Operator: Highpoint Operating
Location Name: Randall Creek 1-28H
Loc ID: 416391
Inspection: 696306087

Exhibit A

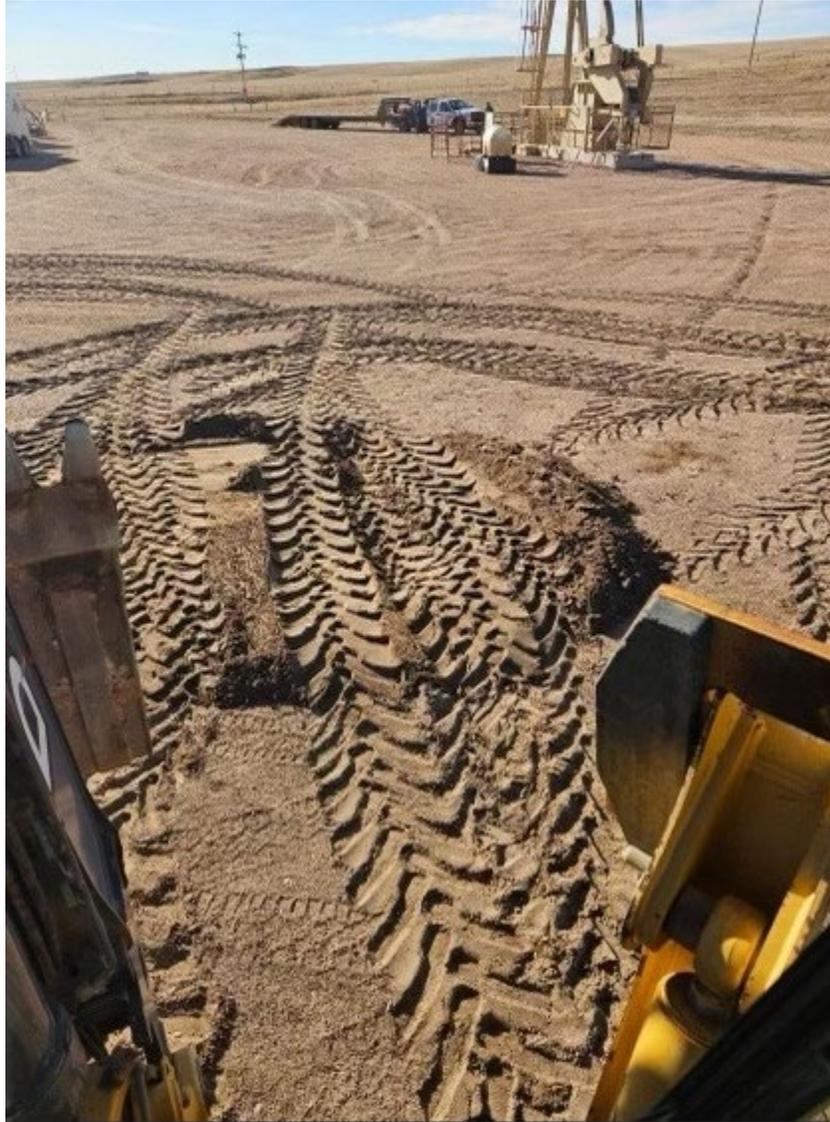
CA: South West and North West Deadman Anchors are not marked. Install proper guy line markers per 1003.a.

CA Resolution: Deadman Anchors have been removed to comply with Rule 1003.a.
